Access Compliance Report

Public Rights-of-Way

(Curb Ramps)

| Intersection ID: 51059 | Main Street: CORY-BRET_LN | Cross Street: CRAIGMOSS_LN | Location: SE |

| ADA ID: 48E0FBE43453 | Ramp Type: Perp | Initial Pass/Fail: Fail | Overall Compliance: No |

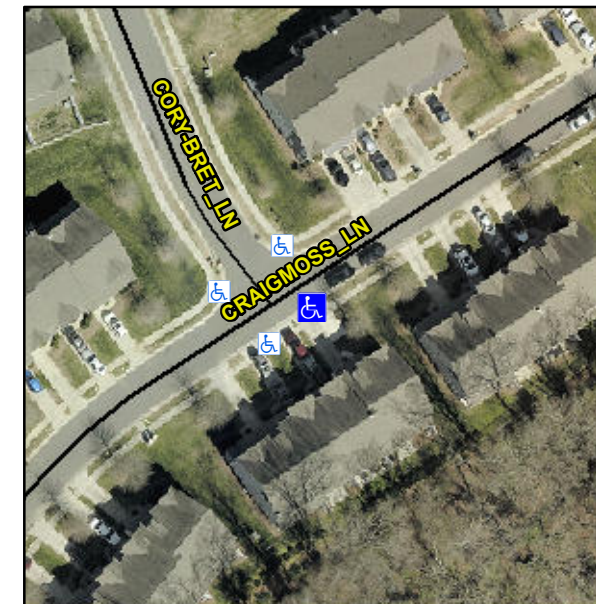
Not Found, R304.2.2

| Compliance | Description | Data | Compliance | Description | Data |
|------------|-----------------------|-------|------------|-----------------------------|------|
| N/A | Ramp Length (in) | 48.0 | No | Ramp Slope (%) | 8.4 |

Remove & Replace Entire Ramp.
